Response to Submissions and Amendments to Proposed Development

Sydney International Convention, Exhibition and Entertainment Precinct (SICEEP)

Darling Square - South East Plot Mixed Use Residential Building

Submitted to Department of Planning and Environment
On Behalf of Lend Lease (Haymarket) Pty Ltd

Figure 2 – Key articulation/modulation moves adopted within SE1

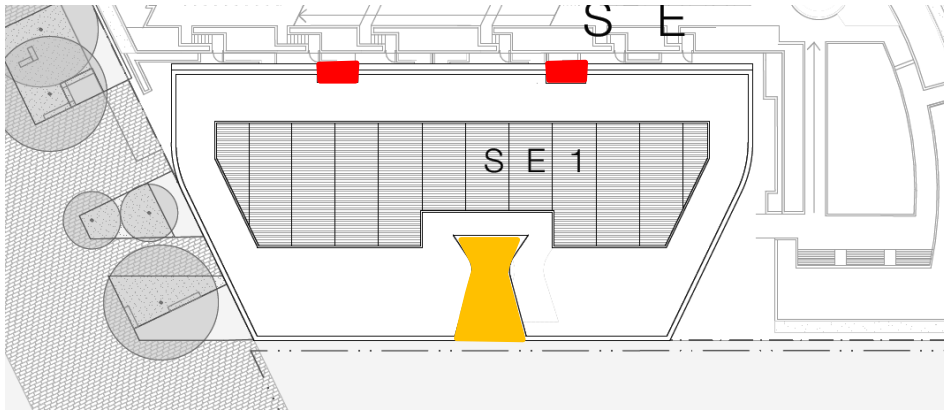
Building Articulation/Modulation

A number of design measures have been adopted by fjmt to deliver high quality and highly articulated building forms. In the instance of SE1, the following key measures are adopted:

- Provision of a wide and deep vertical slot that runs up the middle of the southern façade – effectively creating ‘twin towers’ (refer to **Figure 2**);
- Breaking the northern façade down into three forms through vertical balcony recesses (refer to **Figure 2**); and
- Modulated and varied matrix of windows and panels to the eastern and western elevations (refer to **Figure 3**).

Figure 7 – Activation levels along Hay Street
Source: *fjmt*

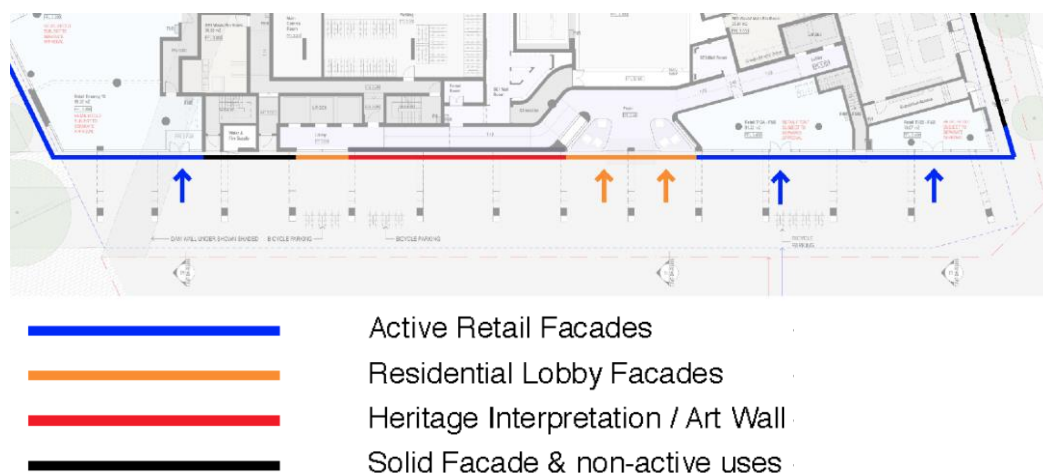
The Department has also requested clarification on the measures to prevent antisocial behaviour and vagrancy within the undercroft. The activation of the undercroft was a key design consideration for the precinct, and importantly, the South East Plot. Activation of the undercroft will serve as a key deterrent to anti-social behaviour and vagrancy (refer to **Figure 7**).

To achieve this activation, pedestrian desire lines along Hay Street are focused as much as possible toward and through the colonnade. The residential lobby for Building SE1 and Building SE3 is located midway along the undercroft and will focus the foot traffic to 362 apartments to and through the colonnade.

Two retail tenancies have been located on the corners of the Boulevard and Harbour Street, anchoring the ground plane of the development and encouraging activity in the colonnade space. Activation will be achieved by providing outdoor dining in the case of a retail food tenancy or dynamic shop front displays in the case of traditional retail. This in combination with expansive glazed retail facades will ensure the space has a sense of activation. To prevent vagrancy, the extent of any 'nooks' along the façade have been minimised to ensure the space is perceived as safe. This principle of safety will be further reinforced through effective lighting in the colonnade.
